PLANNING REPORT

Planning and Zoning Commission

CMR/CH HOTEL AND CONDOMINIUMS 22-152INF

www.dublinohiousa.gov/pzc/22-152

Development Concept

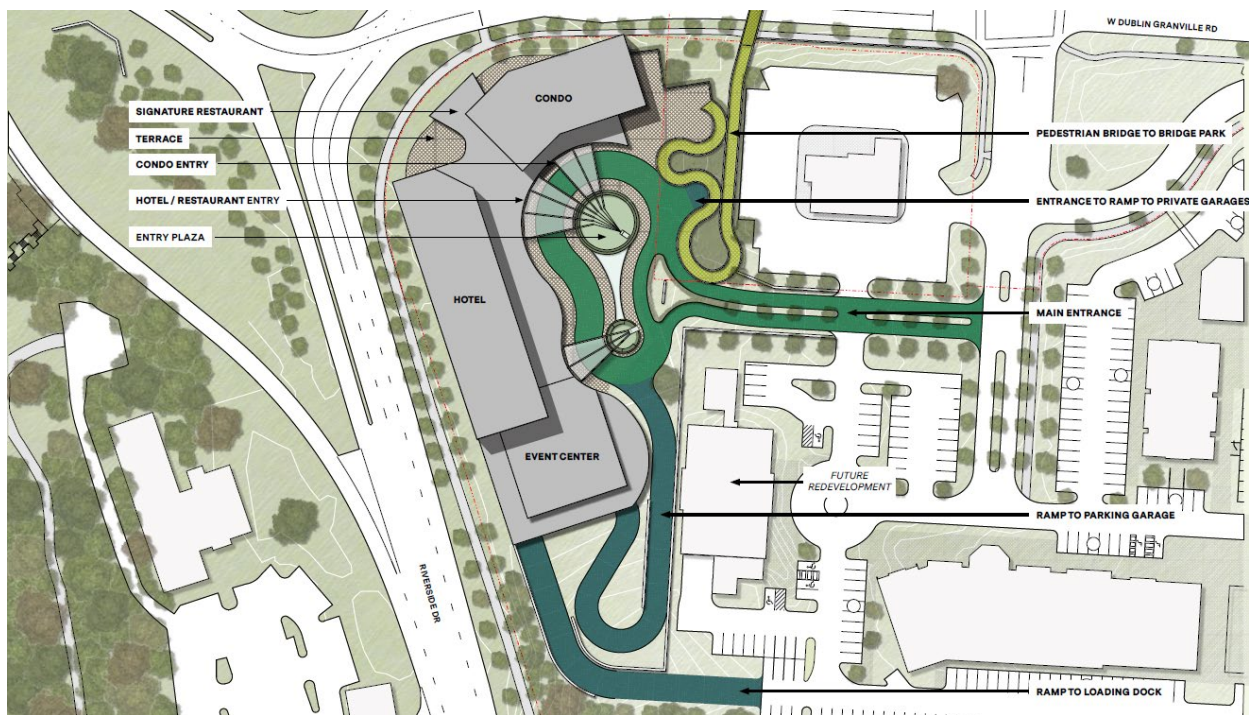
1) Is the Commission supportive of the proposed uses and general site layout of the development?

The applicant is proposing new development at the intersection of W. Dublin-Granville Road and Riverside Drive on the 2.85-acre site that contains 4 uses within the buildings, including a condominium use along W. Dublin-Granville Road, a restaurant use at the roundabout of W. Dublin-Granville Road and Riverside Drive, a hotel use along Riverside Drive, and an event center at the southern end along Riverside Drive. The buildings features podium parking beneath the complex, with no surface parking proposed on site. The site plan conceptually calls for terrace space at the roundabout, with an entry

2) Is the Commission supportive of the proposed massing of the mixed-use building?

The applicant is proposing a building complex that includes multiple different forms and heights. The site includes a 9-story condominium massing in the northern portion of the complex, a 7-story hotel and amenity roof massing located centrally in the complex, and a 2-story event center massing in the southern portion of the complex. The proposed development fronts on two Principal Frontage Streets, as required by Code. The renderings show two lower levels (LL1 and LL2) and ground level parking garage that appear elevated above grade, which would increase the amount of stories provided for the building. The applicant would need to provide additional detail with a future application to indicate whether these will be above or below grade. Parking within a building is conditionally permitted in many building types in the District, but is only allowed to the rear of the first 3 floors. Based on the provided plans, LL1 appears to be visible above grade, with the ground level being the first main floor of the building. Parking is permitted to be fully within the basement of many building types in the District.

The applicant has not provided building types for the proposed development. However, the maximum story height permitted in the Bridge Street district is 6 stories (Corridor Building). A Waiver would be required to exceed the maximum story height in this location. Based on the topography of the site, this is the lowest lying site within the BSD-Scioto River Neighborhood and the lowest along Riverside Drive. To the east of the site, the Shoppes at River Ridge features a shopping center with buildings not exceeding 2 stories in height, with an existing office complex not exceeding 2 stories in height immediately south of the property.

3) Is the Commission supportive of the proposed vehicular and pedestrian access for the site?

The site is accessed from the east by a split boulevard connecting to a private portion of Dale Drive between Wendy's and the Shoppes at River Ridge. The boulevard provides access to a covered entry plaza, and continues to provide access to the podium parking below the development. At the southern end of the property, vehicular access is provided to the loading dock from an existing drive aisle to the southeast of the development. Vehicular access is not provided from either of the principal frontage streets of the development, consistent with the Bridge Street Code. The proposed vehicular access to the east of the site is consistent with the Code, requiring access to the lowest designated street adjacent to the site. Dale Drive is considered a neighborhood street in the Street Network Map, and would require additional analysis as to where the public portion of the site should be extended with the development of this site. Given the nature of the uses of the site and limitation of access points to the east, the site appears to be developed with more vehicular focus than pedestrian focus. The Commission should consider whether the layout of the site contributes to the goals of pedestrian-oriented development within the District.

Currently, the proposal does not show a connection to the existing pedestrian infrastructure along Riverside Drive or W. Dublin-Granville Road. The applicant is proposing a new pedestrian bridge in the northeast corner of the site, crossing W. Dublin-Granville Road. The pedestrian bridge is accessed on site through a proposed terrace to the east of the condominium tower, before crossing W. Dublin-Granville Road to connect to Bridge Park on the north side of the street. The pedestrian bridge is a type of facility that is not contemplated in our Code, and would require additional discussion with City Staff if the opportunity were pursued. The City is in the introductory stages of conducting a streetscape corridor study along W. Dublin-Granville Road to identify opportunities to make the W. Dublin-Granville Road Corridor more pedestrian friendly. The study will identify speed management strategies, implement more urban-style access management along the corridor, and improve crosswalks along the corridor. The goal of the Bridge Street District is to create a safe and comfortable pedestrian-oriented development at a street level. The pedestrian bridge is proposed to only be accessed on site and does not connect to the existing pedestrian network along the street frontages. The Commission should consider how the proposed pedestrian facilities would affect the vision of making the District a walkable environment.
